RE: Wayne Glen Conditional Use Binder – minor revisions #2

Please find enclosed a few replacement sheets for the Wayne Glen Conditional Use Binder.

Graph 2. A bar graph representing the runoff volume for the site for various scenarios. The runoff volume for the Wayne Glen site for the 2-year storm will be 0-cf.

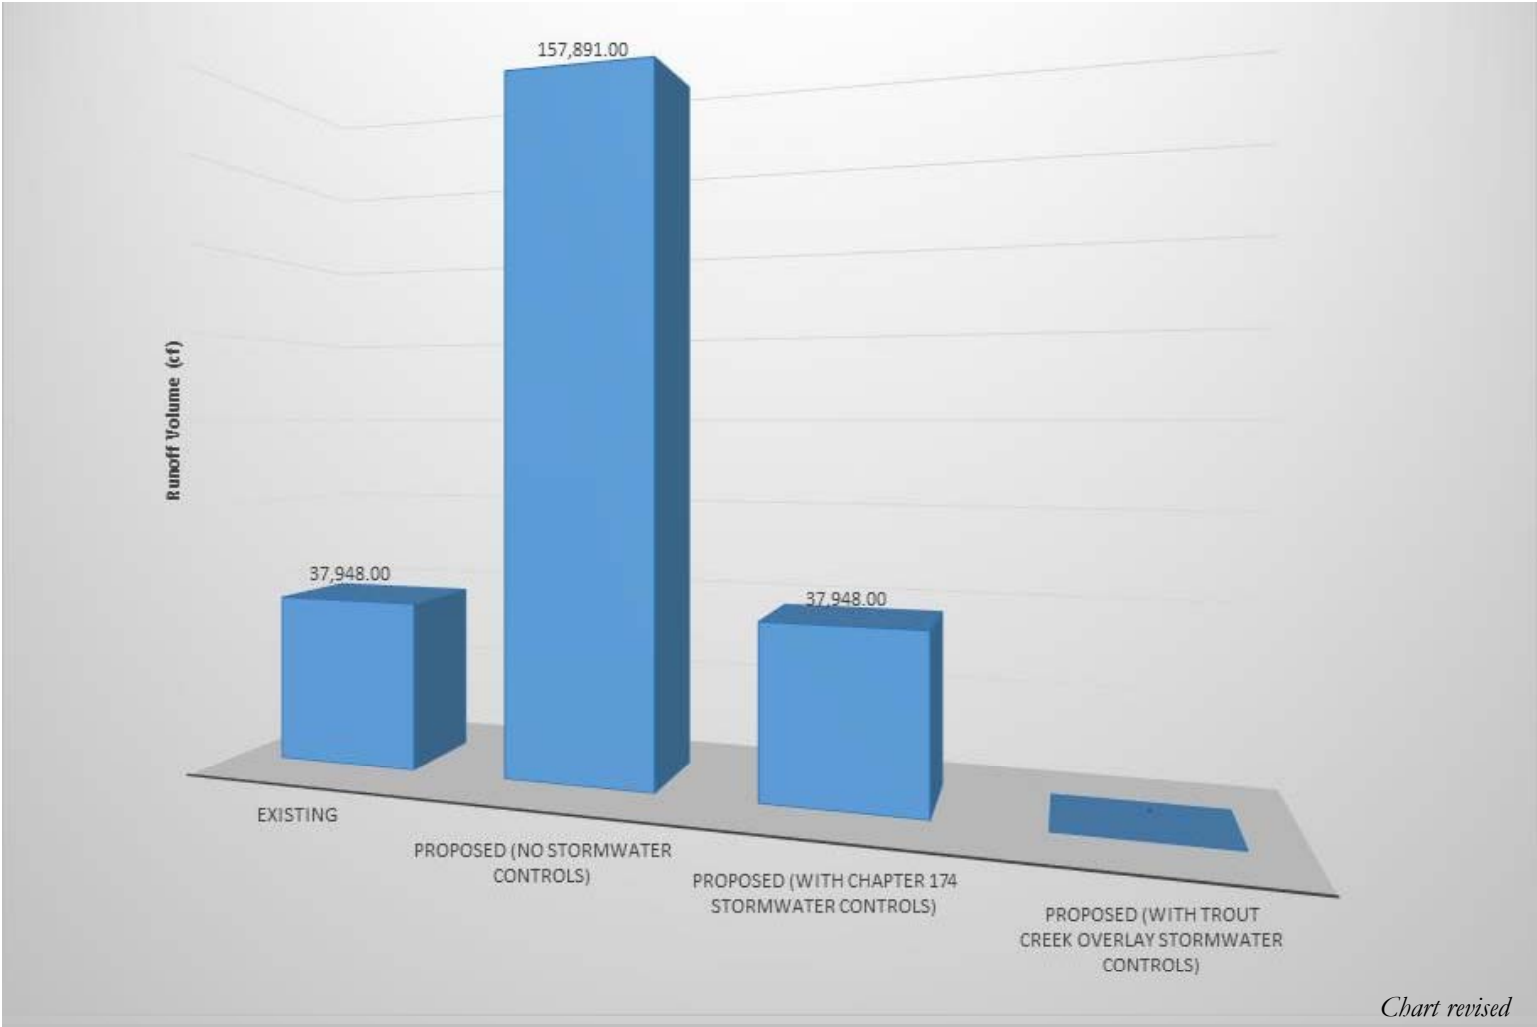
- **Exhibit 1. “PPT Presentation for 1/5/15 CU Hearing”**
 - Pg 19 – Pennoni’s Graph 2 was slightly modified
 - Pg 31 – A typographical error in the code reference in the title was corrected.

Graph 2. A bar graph representing the runoff volume for the site for various scenarios. The runoff volume for the Wayne Glen site for the 2-year storm will be 0-cf.

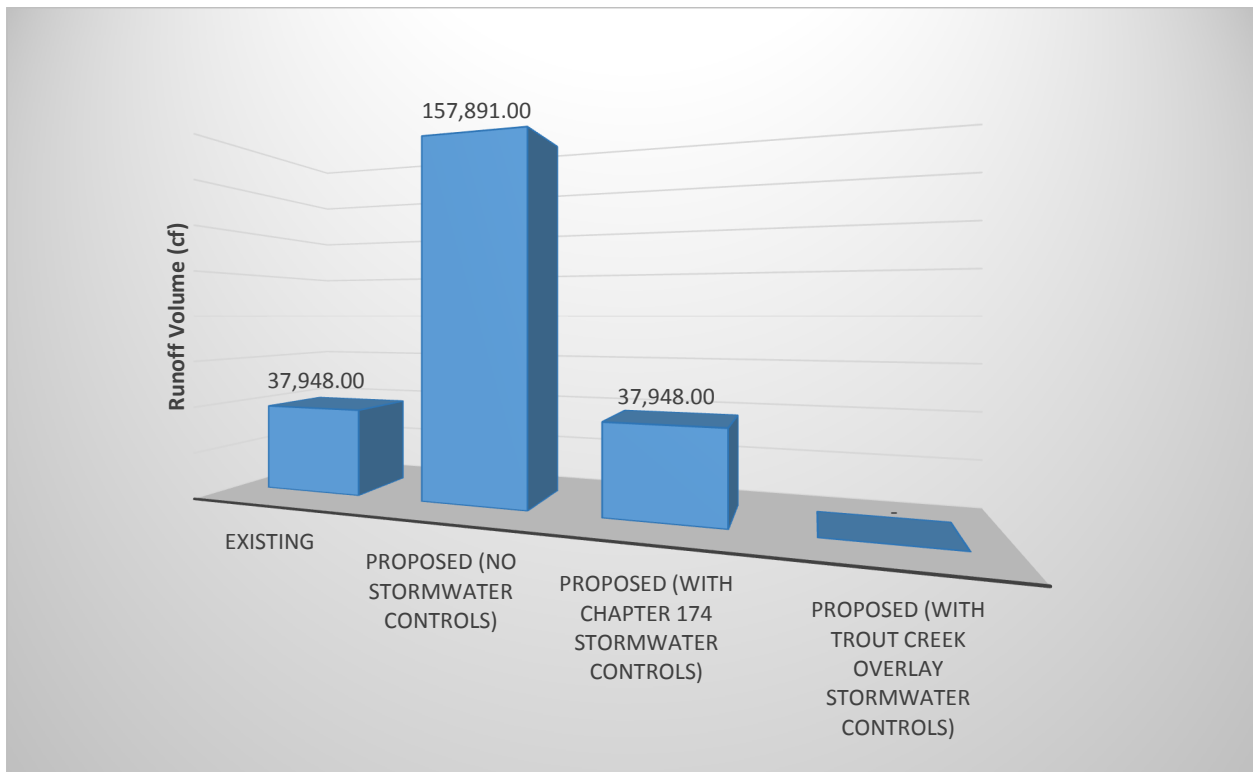
- **Exhibit 3. “Stormwater Management Report Summary”**
 - Pg 14 – Graph 2 was slightly modified (consistent with the above modification of Pg 19 of Exhibit 1).
